TSB - CAS05

Models applicable > Case/David Brown 770>1294
Ag Clutch Part Numbers > 125 2501 CA and 128 2801 CA

CLUTCH COVER REPLACEMENT

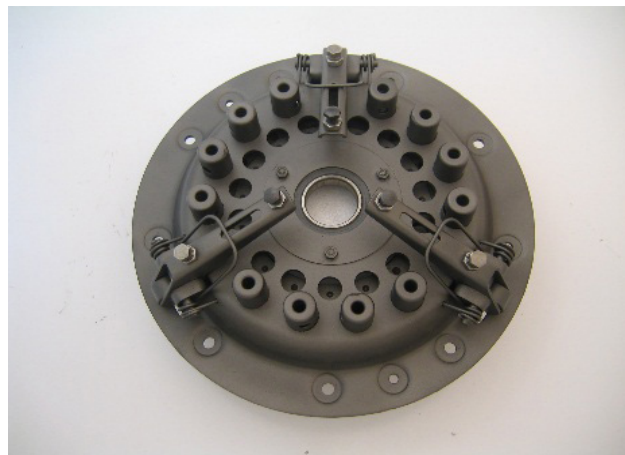
The original Laycock manufactured clutch cover shown above is now replaced with the aftermarket style that has a release bearing plate fitted - these covers interchange directly without the need for special modification.

The new cover assembly is factory set to suit the original thickness mated components and flywheel depth. However, if all the components are not replaced the setting may change. It is recommended that this dimension is checked in the tractor.

Install the cover on the flywheel with the intermediate and clutch plate to be fitted. Check the PTO grub screw clearance, and if necessary adjust this by using a feeler gauge or similar. This can be accessed through the side of the cover in 3 positions.

The recommended clearance is .060" to .065" (1.5mm to 1.65mm)
